Form 3160-5
(June 2019)UNITED STATES
DEPARTMENT OF THE INTERIOR
BUREAU OF LAND MANAGEMENTFORM APPROVED
OMB No. 1004-0137
Expires: October 31, 2021**SUNDRY NOTICES AND REPORTS ON WELLS**
Do not use this form for proposals to drill or to re-enter an abandoned well. Use Form 3160-3 (APD) for such proposals.

8. Well Name and No. STELLA BLUE 30 FED COM/711H

EOG respectfully requests an amendment to our approved APD for this well to reflect the following changes:

WELL LOCATION AND ACREAGE DEDICATION PLAT

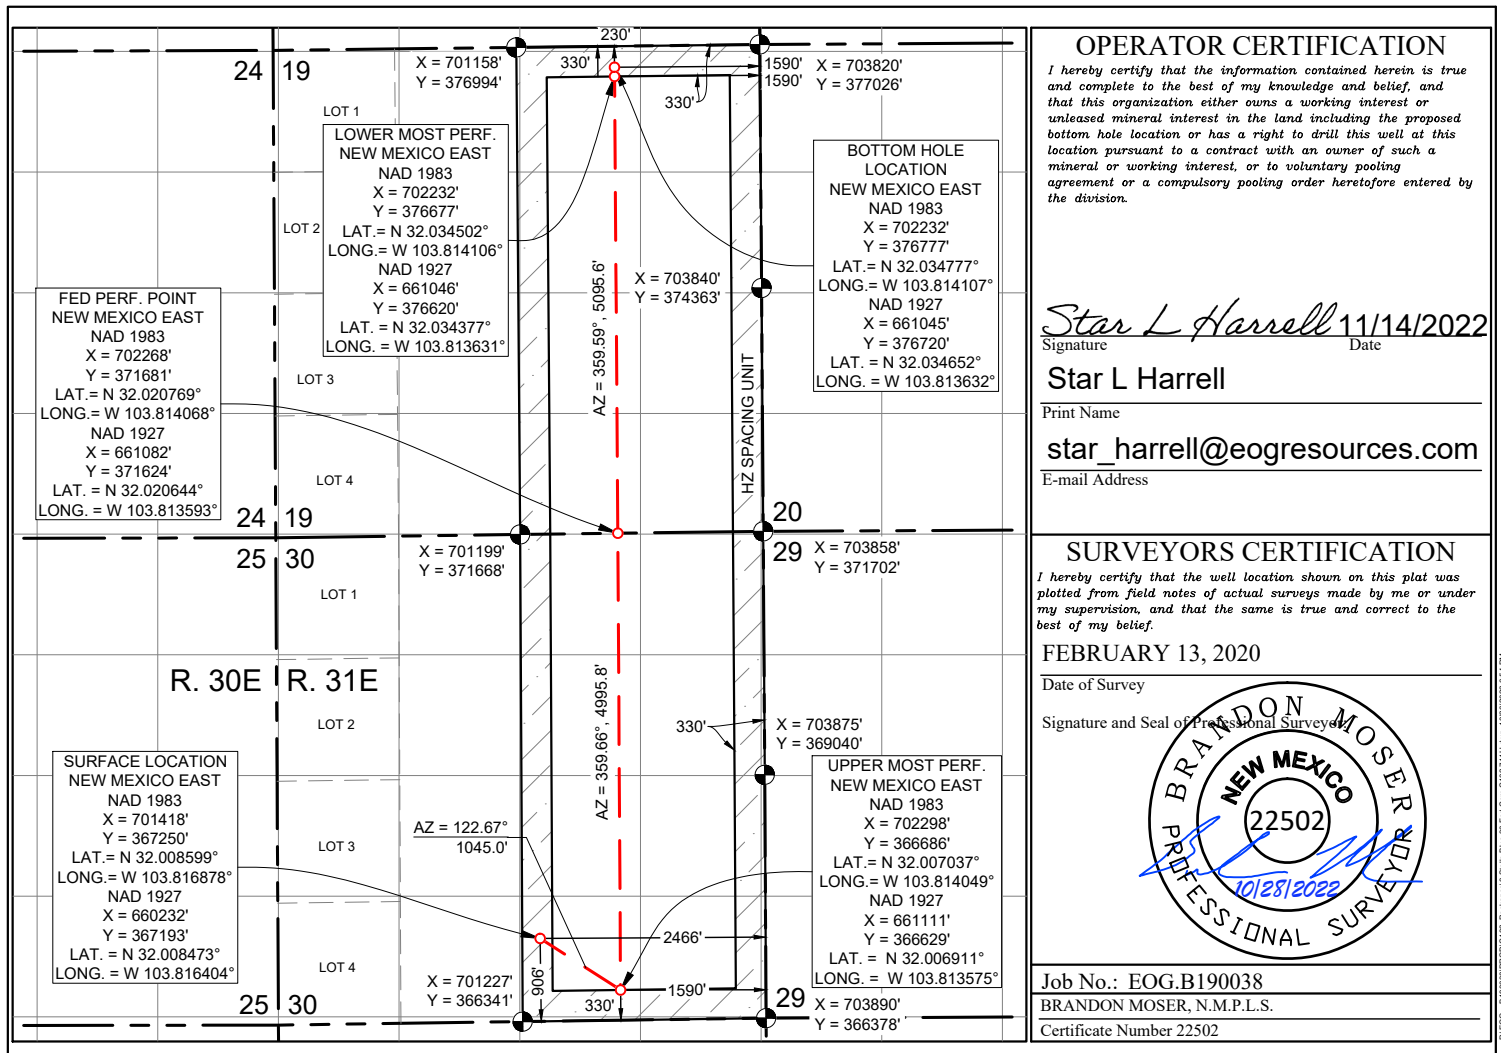
Change BHL from T-26-S, R-31-E, Sec 19, 230' FNL, 1650' FEL, Eddy Co., NM,
to T-26-S, R-31-E, Sec 19, 230' FNL, 1590' FEL, Eddy Co., N.M.

UL or lot no.	Section	Township	Range	Lot Idn	Feet from the	North/South line	Feet from the	East/West line	County
B	19	26 S	31 E		230	NORTH	1590	EAST	EDDY
Dedicated Acres 640.00	Joint or Infill	Consolidated Code	Order No.
